Date: MAR 09 2016
Symbol: EPC-DO-16-056
LA-UR: 16-21078
Locates Action No.: N/A

Subject: Transmittal of Class 1 Permit Modification Notification to Update Figures in the Los Alamos National Laboratory (LANL) Hazardous Waste Facility Permit, EPA ID No. NM0890010515

**Class 1 Permit Modification Structure Changes at Technical
Area 54**

Figure 29: TA-54, Area G, Pad 1

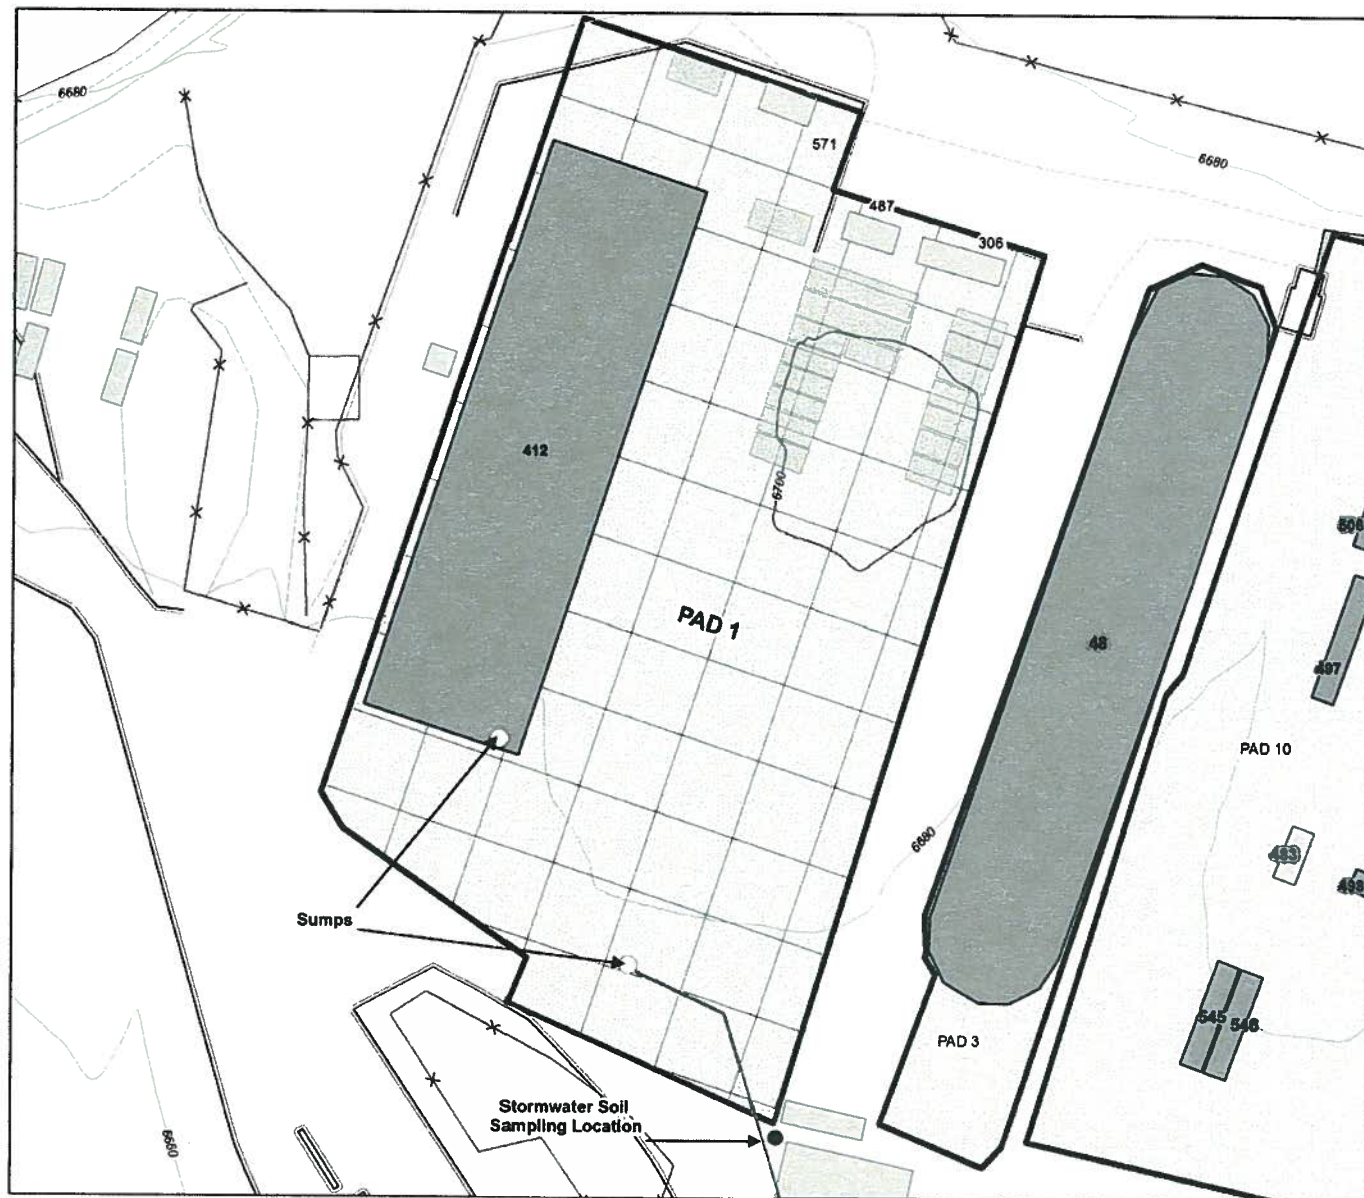
Figure 29 (TA-54, Area G, Pad 1) of Attachment N and Figure G.6-1 (Technical Area 54, Area G, Pad 1 Outdoor Container Storage Unit Grid Sampling Locations) of Attachment G.6 were revised to show the placement of seventeen storage structures at Area G, Pad 1. These structures, which are not “new” structures to Area G but are newly arranged at Pad 1, are not associated with hazardous waste storage activities; therefore, existing structure numbers have been removed.

Figure G.6-2: Technical Area 54, Area G, Pad 1 Outdoor Container Storage Unit Drainage Sampling

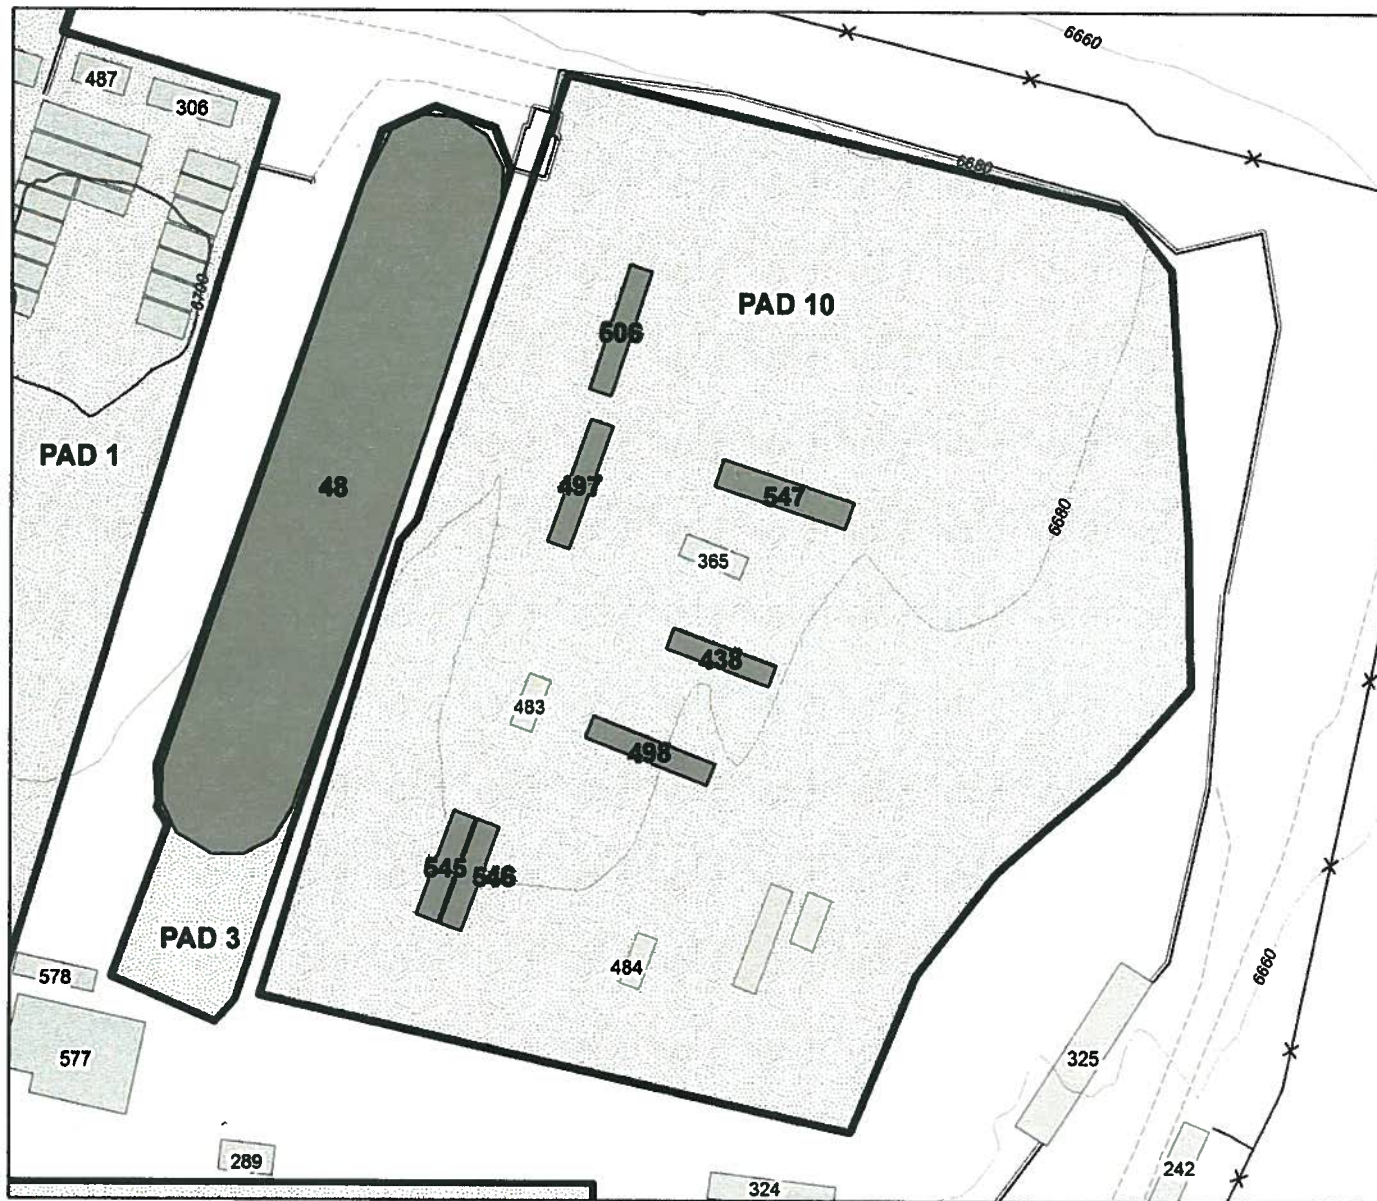
Figure G.6-2 (Technical Area 54, Area G, Pad 1 Outdoor Container Storage Unit Drainage Sampling) of Attachment G.6 was revised to reflect the placement of the seventeen storage structures on Pad 1 (discussed above). To remain consistent with other figure updates, additional changes were made to this figure to show the boundaries and associated structures for Pad 3, Pad

10, and Pad 9. The structures associated with the figure change are not associated with the permitted unit, and they are not used to manage hazardous waste.

Figure G.11-1: Technical Area 54, Area G, Pad 10 Outdoor Container Storage Unit Sampling Grid and Additional Sampling Locations

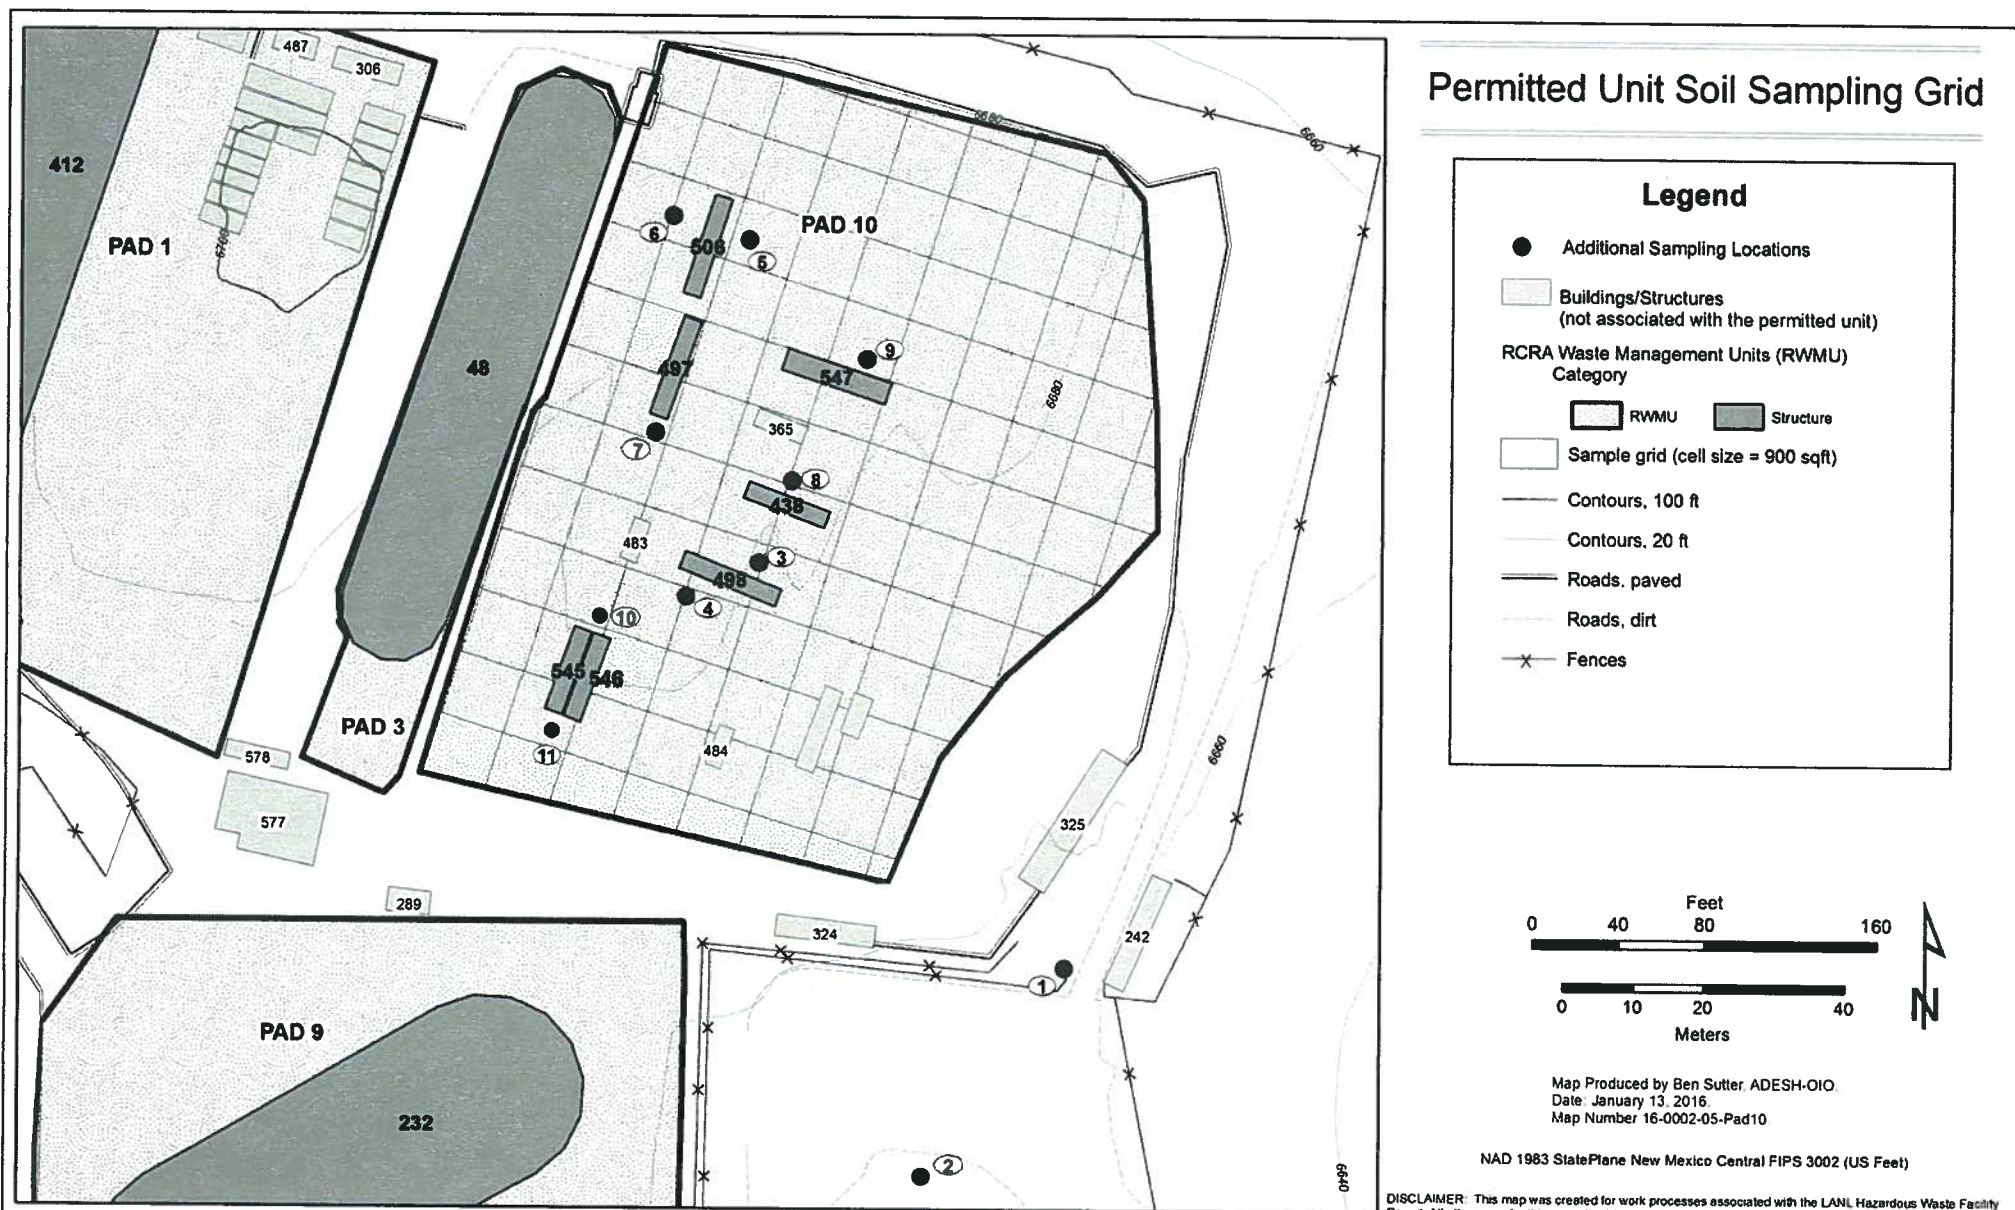
Figure 31 (Technical Area (TA)-54, Area G, Pad 10) of Attachment N and Figure G.11-1 (Technical Area 54, Area G, Pad 10 Outdoor Container Storage Unit Sampling Grid and Additional Sampling Locations) of Attachment G.11 were revised to remove storage trailer TA54-1059, which was relocated to Pad 1 to serve as a storage structure. Other revisions to Figure 31 and Figure G.11-1 include the addition of three support structures (TA54-484 and two additional storage trailers), which were moved to the Pad to serve as storage for equipment and supplies. These structures, which are currently located on the south east corner of Pad 10, are not associated with the permitted unit and are not used to manage hazardous waste. Other changes to the figures were incorporated for the units surrounding TA-54, Area G, Pad 10 container storage unit as appropriate and described within this permit modification.

Figure 28: Technical Area (TA)-54, Area G, Pad 9 (TWISP Domes 229, 230, 231 & 232)

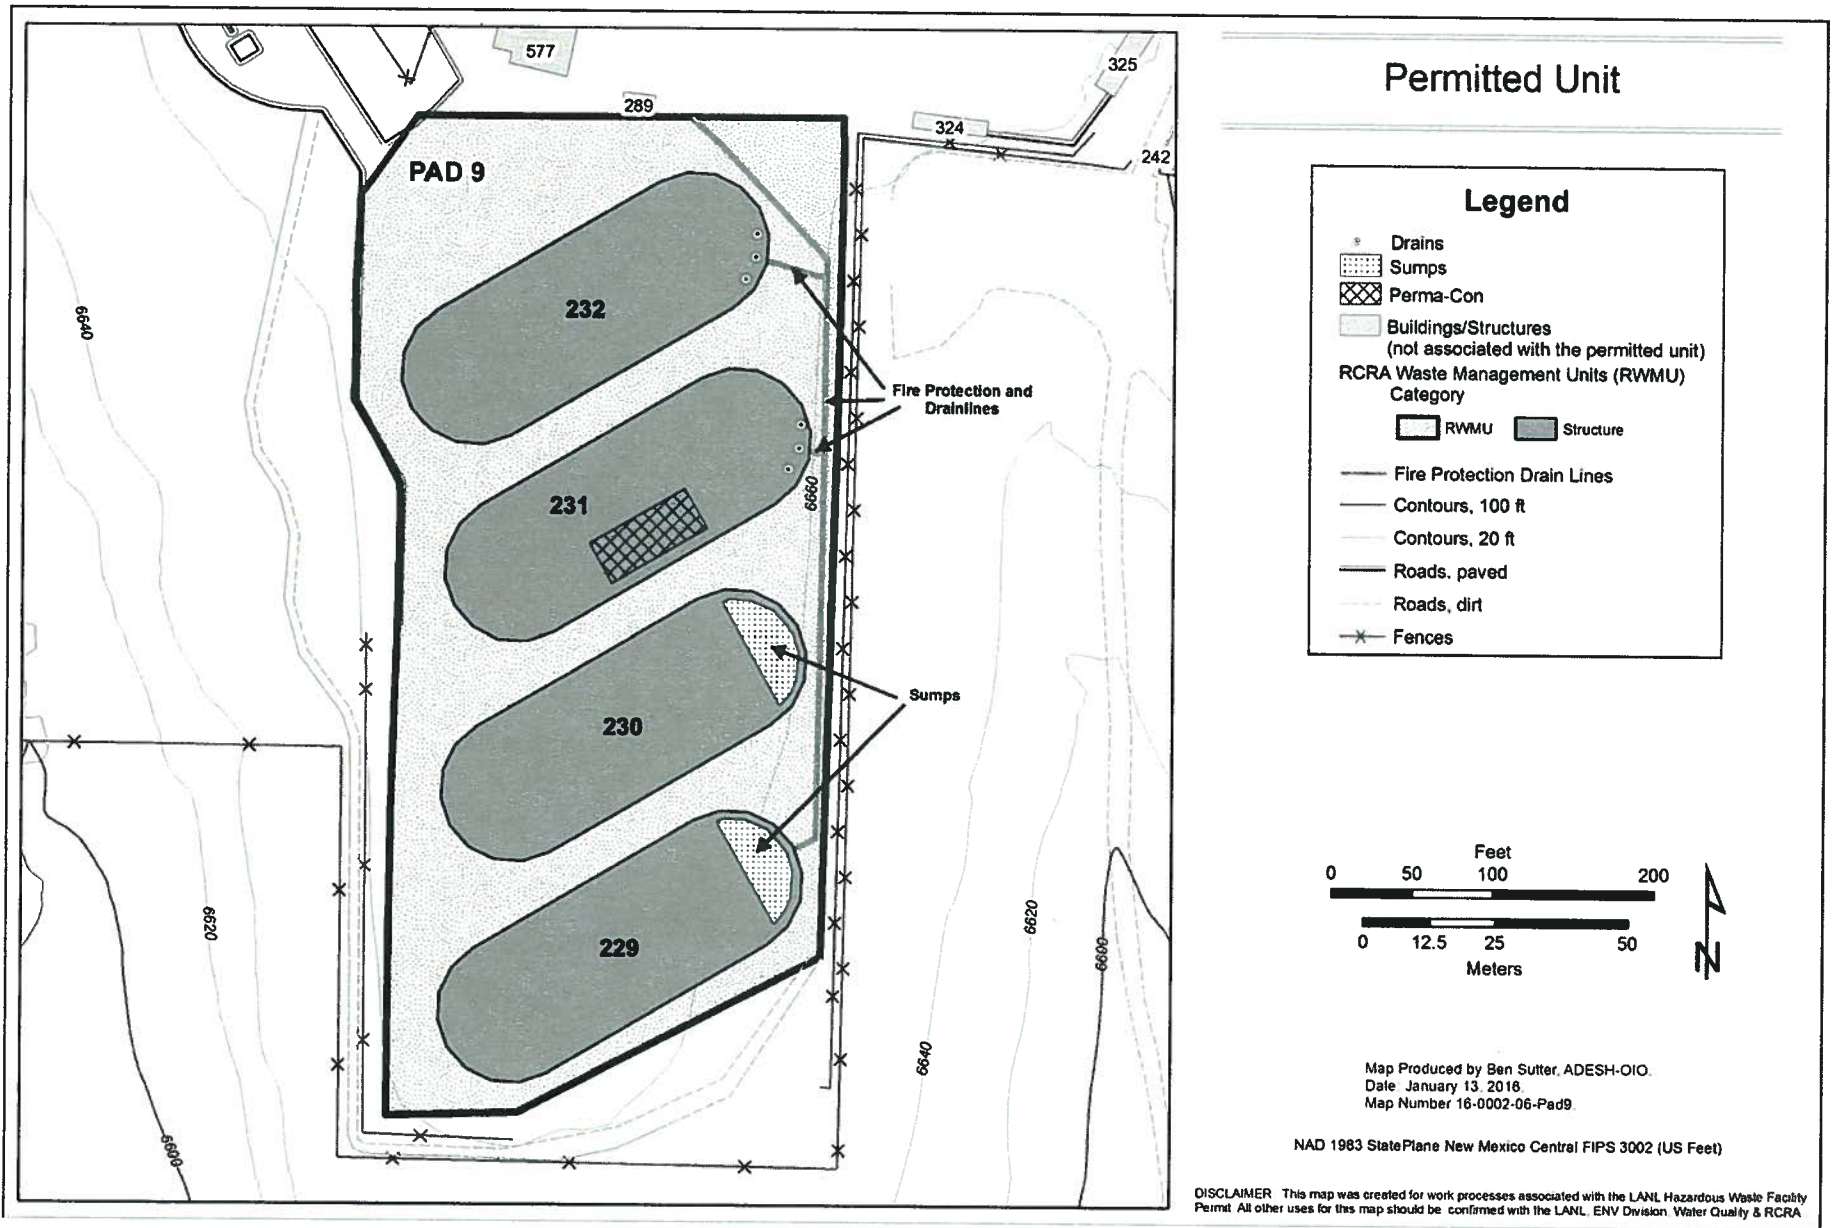
Figure 28 (Technical Area (TA)-54 Area G, Pad 9, (TWISP Domes 229, 230, 231 & 232)) of Attachment N and Figure G.10-1 (Technical Area 54, Area G, Pad 9 Outdoor Container Storage Unit) of Attachment G.10 were revised to remove storage shed 574. This structure, which was relocated to Pad 1 to serve as a storage structure, is not associated with Permit activities or the management of hazardous waste. An additional change was made to Figure G.10-1 to correct typographical errors in the figure's title. The title has been revised from “Figure G.10-1: Technical Area G, Pad 9 Outdoor Container Storage Unit Grid Sampling and Additional

Figure G.10-1: Technical Area 54, Area G, Pad 9 Outdoor Container Storage Unit Grid Sampling and Additional Sampling Locations

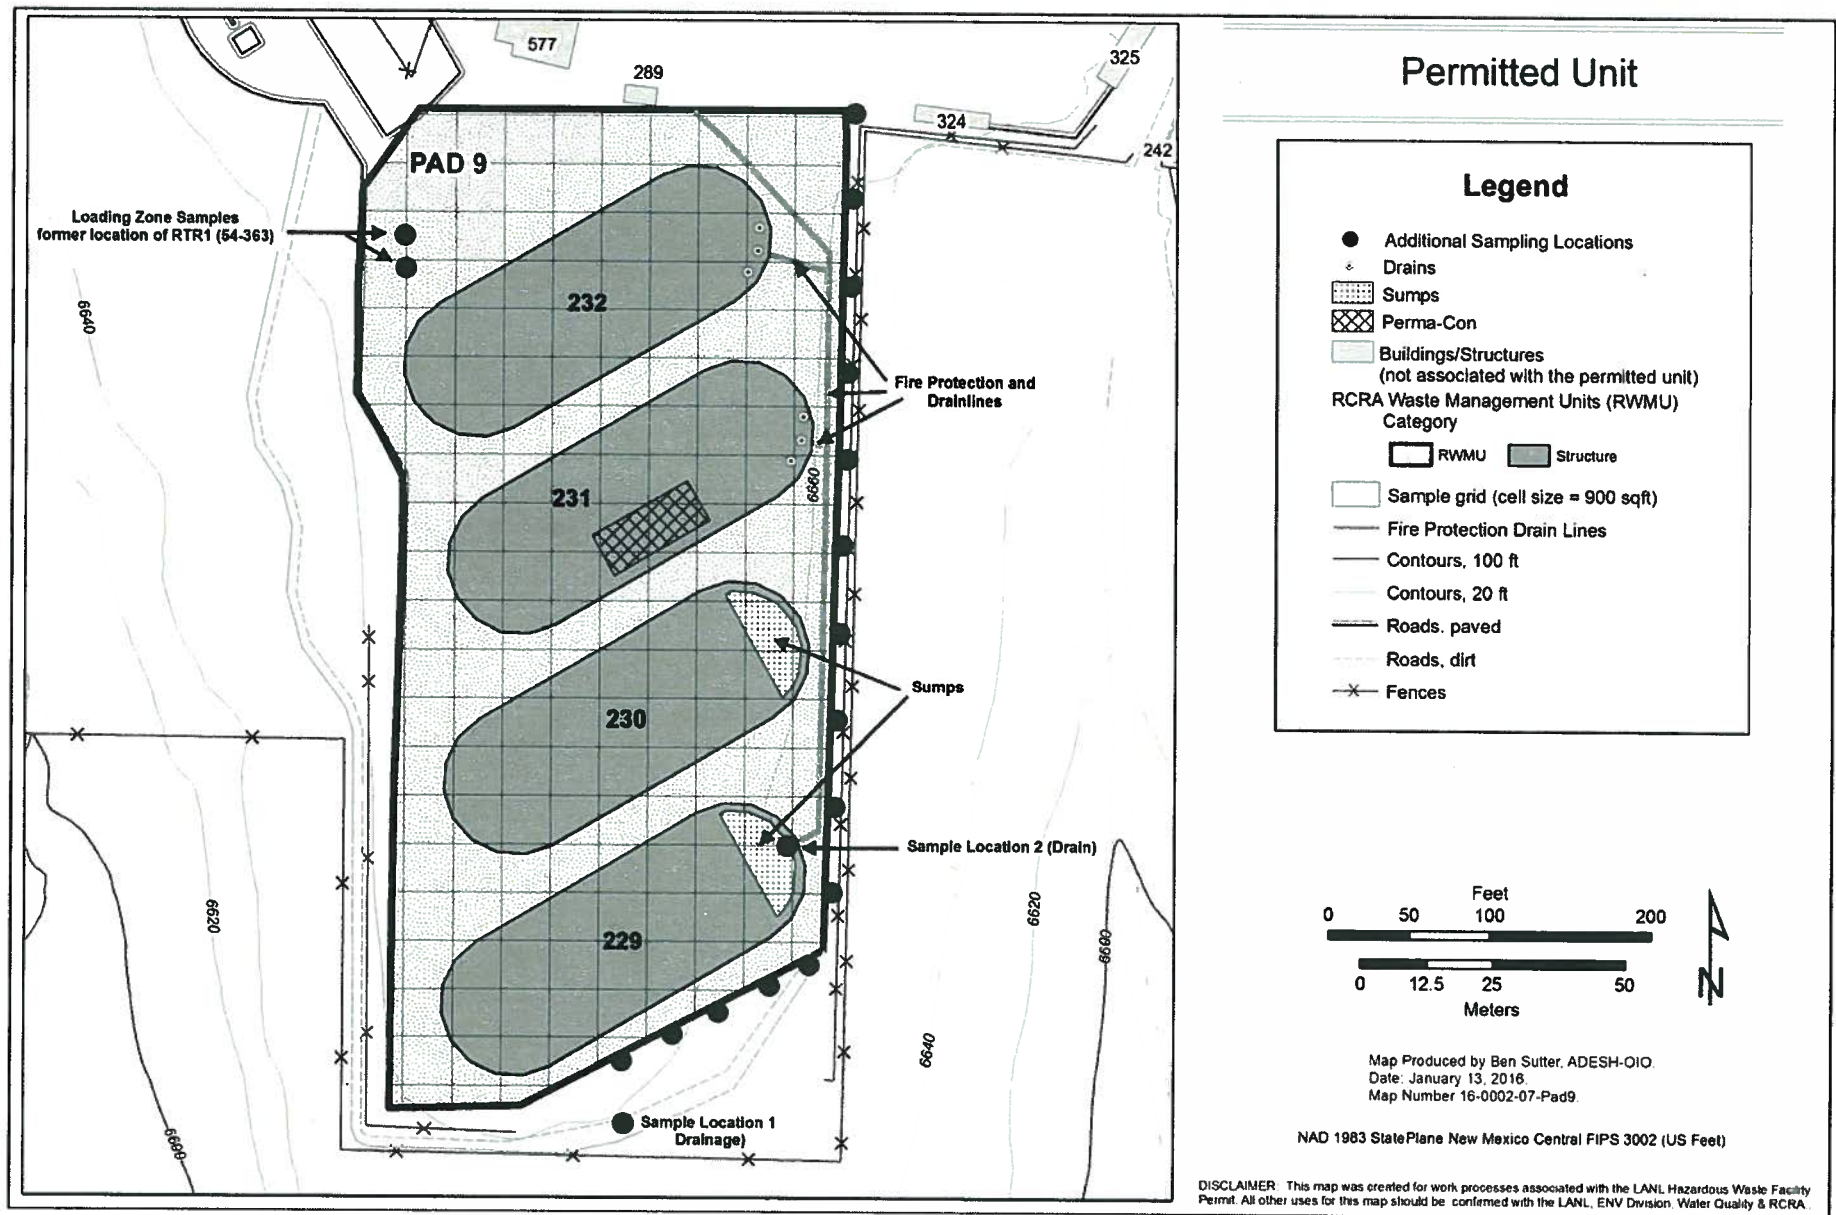
Sampling Locations” to “Figure G.10-1: Technical Area 54, Area G, Pad 9 Outdoor Container Storage Unit Grid Sampling and Additional Sampling Locations.”
